**RE: Skilled Nursing Facility, 1610 Renaissance Blvd NE  
Grading and Drainage Plan  
Engineer's Stamp Date 5-21-2015 (File: F16-D017)**

Based upon the information provided in your submittal received 5-22-15, the above referenced Grading Plan cannot be approved for DRB action on the Site Development Plan for Building Permit until the following comments are addressed:

<b>SKILLED NURSING FACILITY RENAISSANCE CENTER</b>	DRAWN BY DY
	<b>CONCEPTUAL GRADING AND DRAINAGE PLAN</b>	DATE 5/21/15
		2014088-GRE
TIERRA WEST, LLC 5571 MIDWAY PARK PLACE NE ALBUQUERQUE, NM 87109 (505) 858-3100 www.tierrawestllc.com		SHEET # <b>C2</b>
RONALD R. BOHANNAN P.E. #7988		JOB # 2014088

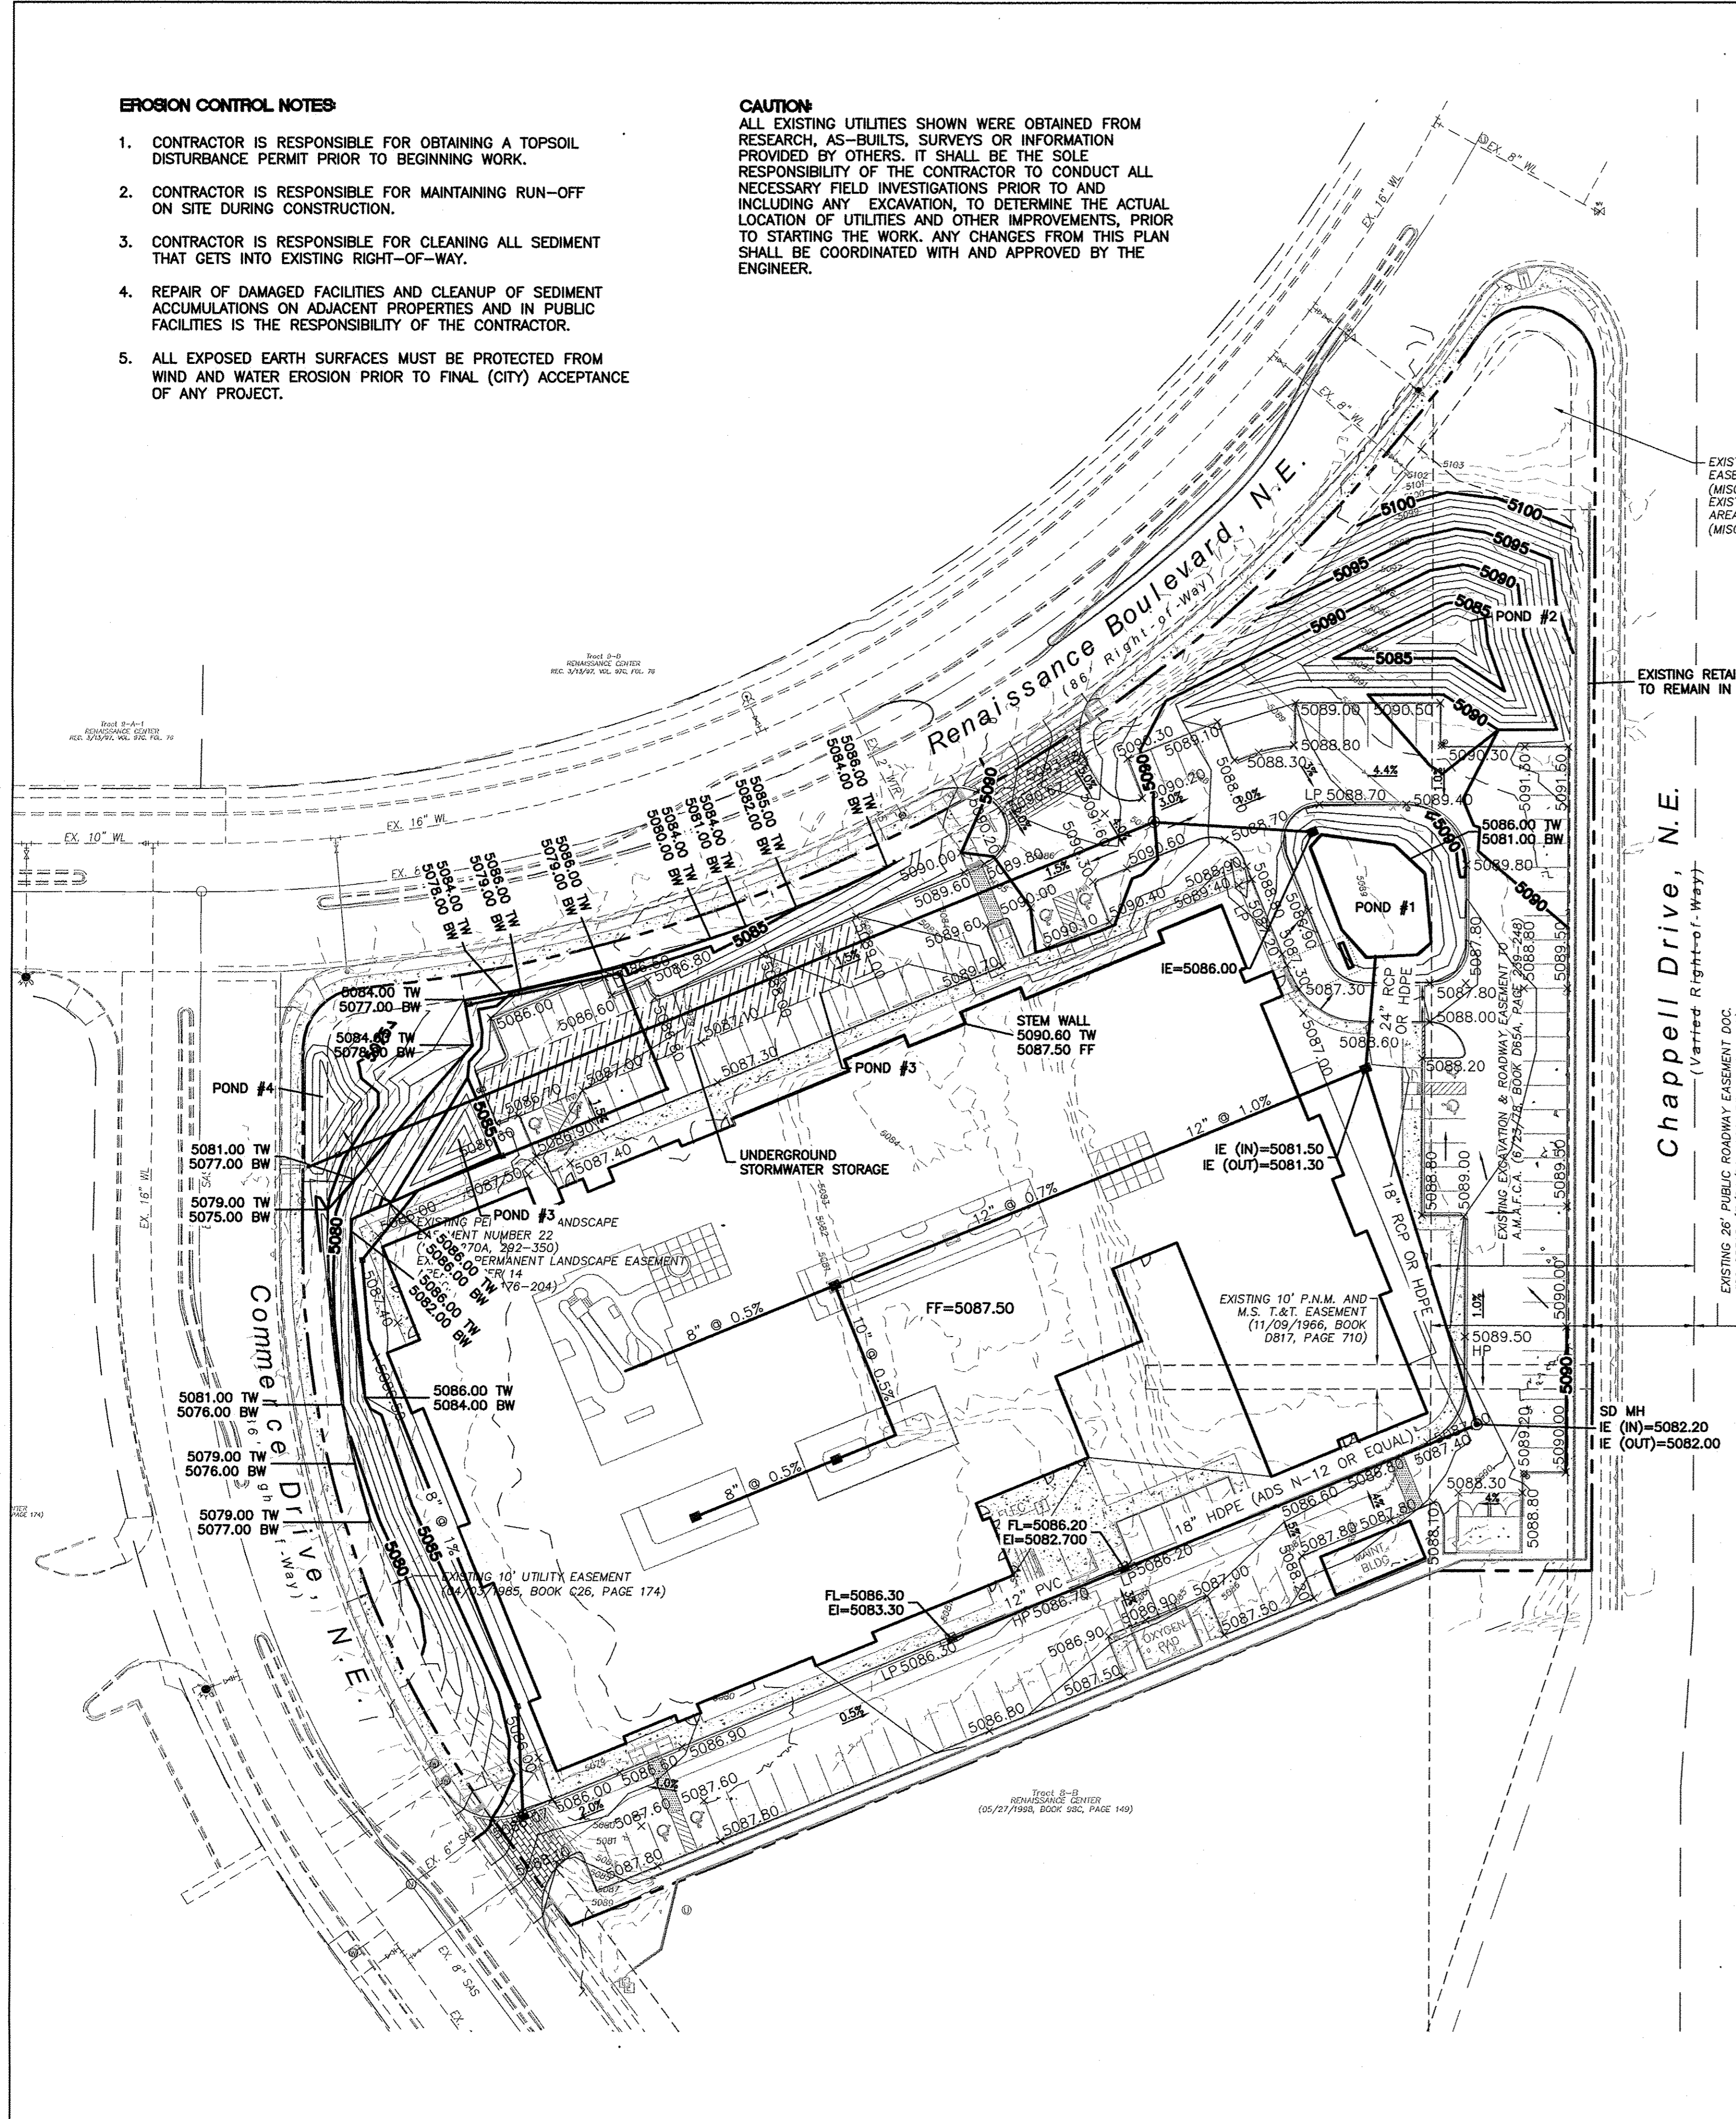
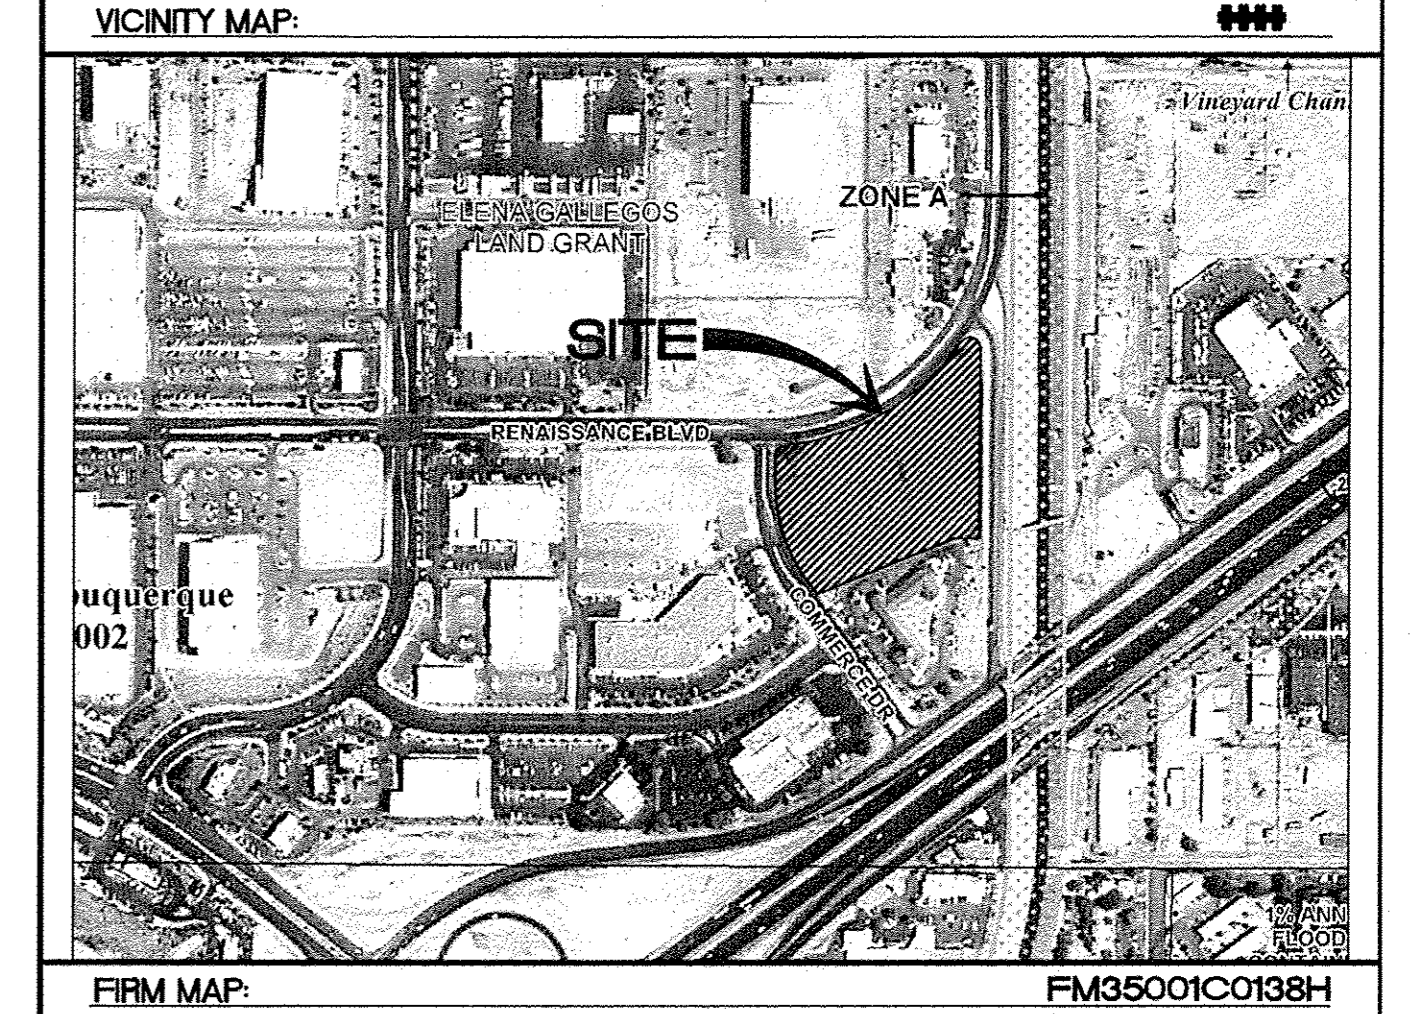
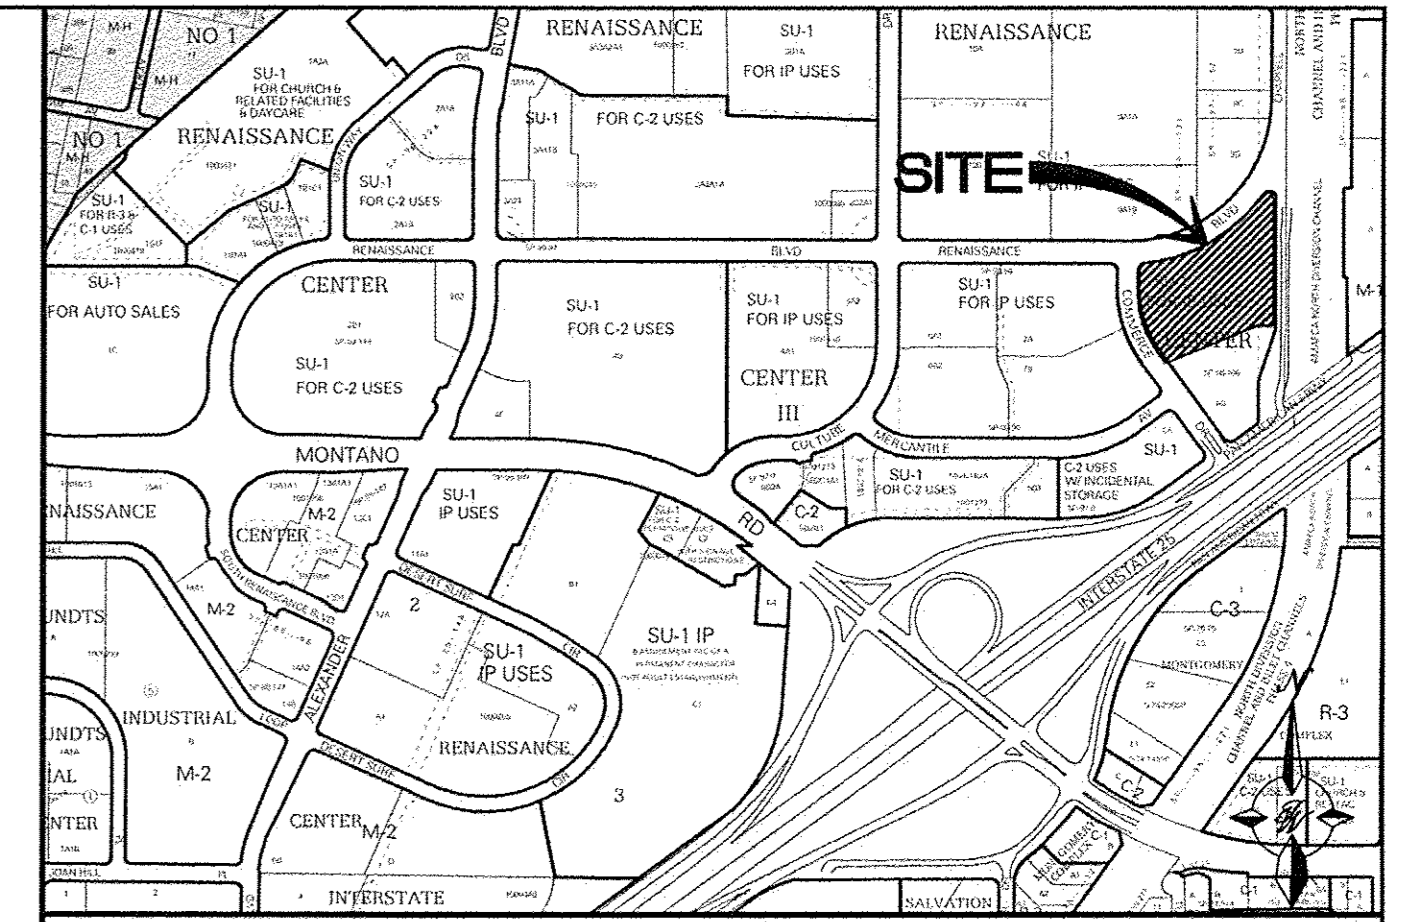
- 1) Provide 100-year storm flow computations for existing and proposed conditions. Show basin boundaries. Also provide first flush computations.
- 2) Demonstrate that the site is discharging the allowable flow per the "Renaissance Drainage Master Plan". Label the existing sidewalk culvert on Commerce Drive, culvert size, and flow discharge onto Commerce Drive. Show existing flowline elevation at the outlet of the existing culvert.

- 3) Label existing spot elevations around the perimeter of the site to show relationship of new grades to existing surrounding grades. Indicate that the grading of the site does not adversely impact the property to the south.

- 4) Label pond sizes along with first flush volumes within each pond. Demonstrate that they meet requirements for proposed detention or retention of storm flow.

- 5) Label all proposed storm drain sizes, top of grate elevations, and flow that the storm drain is conveying. Show which way the roof is draining.
- 6) Call out curb cuts as applicable on the east side of the site if the parking lot is draining to Pond 1.

- 7) There is concern about the location of the inlet shown on the upstream side of a wall labeled for Pond 1 (IE=5086.00). Was it meant to place this inlet in the bottom of Pond 1 for detention purposes?
